CHATHAM COUNTY PURCHASING & CONTRACTING DEPARTMENT

ADDENDUM NO. 1 TO 20-0098-4

FOR: AMBUC BASEBALL COMPLEX IMPROVEMENTS

C-203

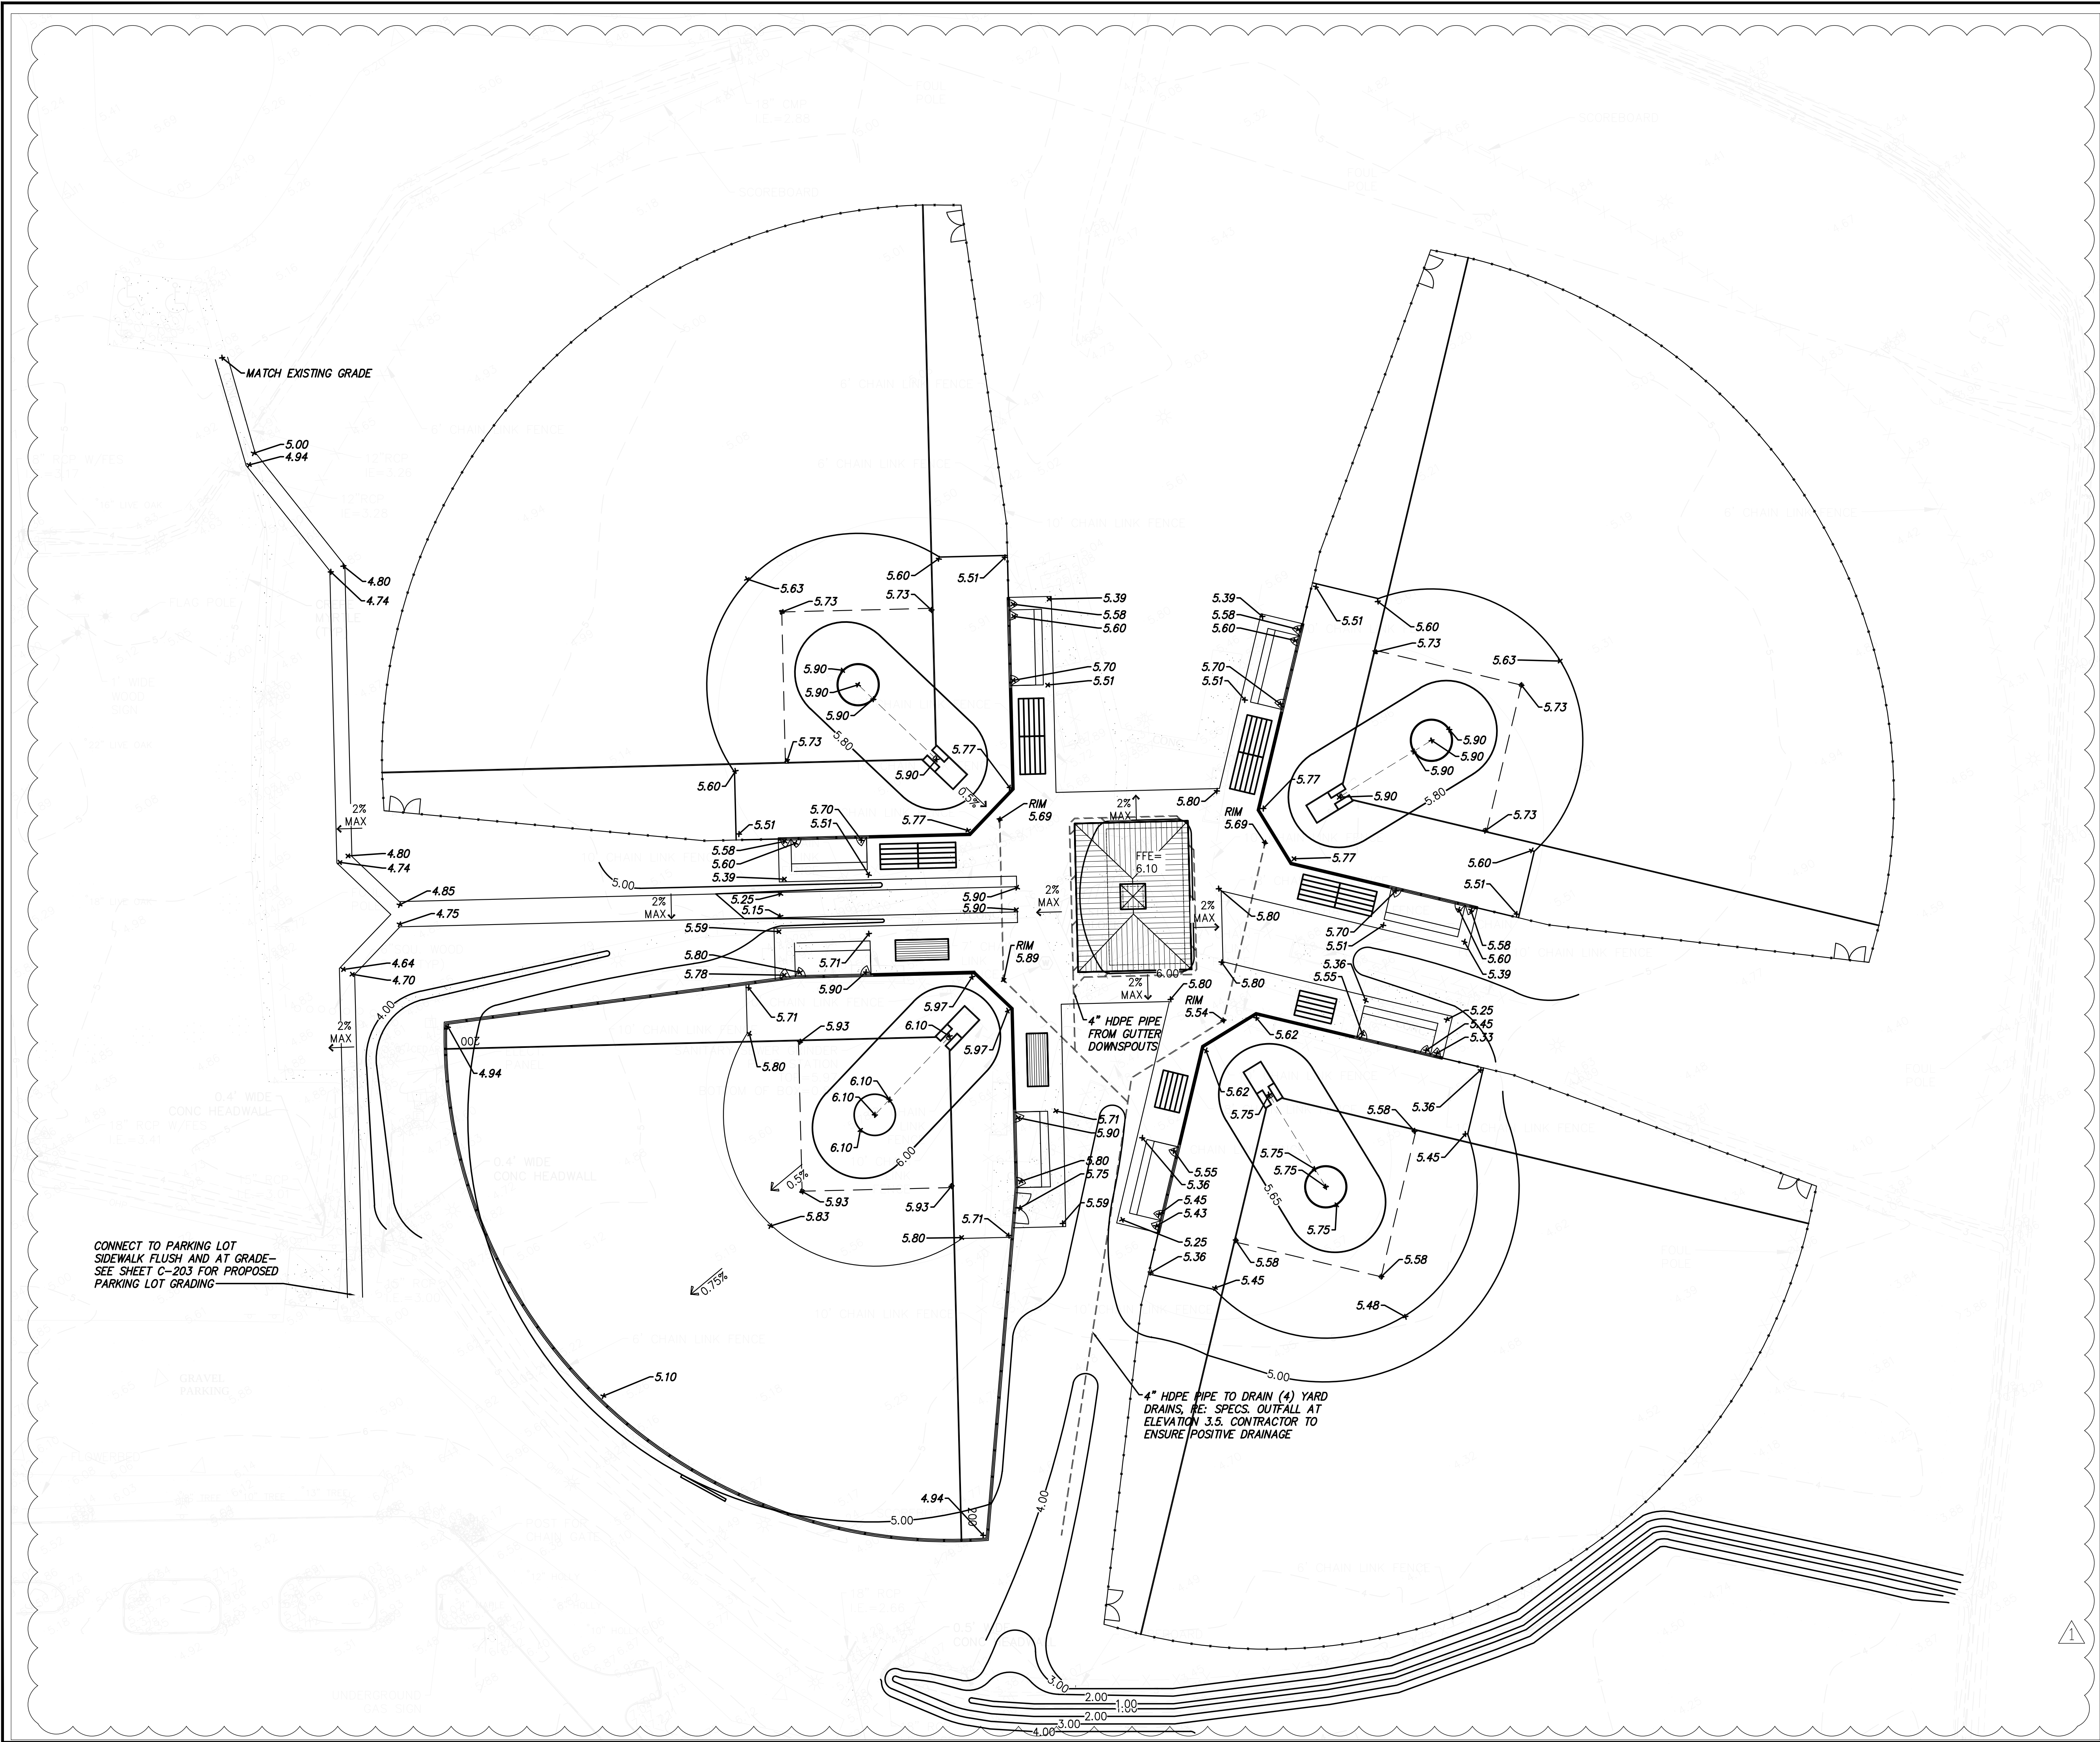
7. Sheet C-201 Site grading page has different proposed grades from sheet C203 Paving & Grading plan in the baseball field area and around clubhouse. Which sheet is accurate? I do not know how I missed that discrepancy?

A) Site grading plans have been clarified as part of Addendum 1. See revised sheets C-201 and C-203.
